RE: PCN # ESU270-46 – SOD882 alternative backend location approval

Product/Process Change Notice (PCN)

SOD882 TVS Diode Array Product
alternative backend location approval

4.0 Packing Method

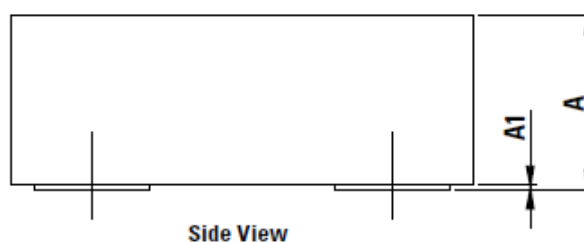
No change of packing method.
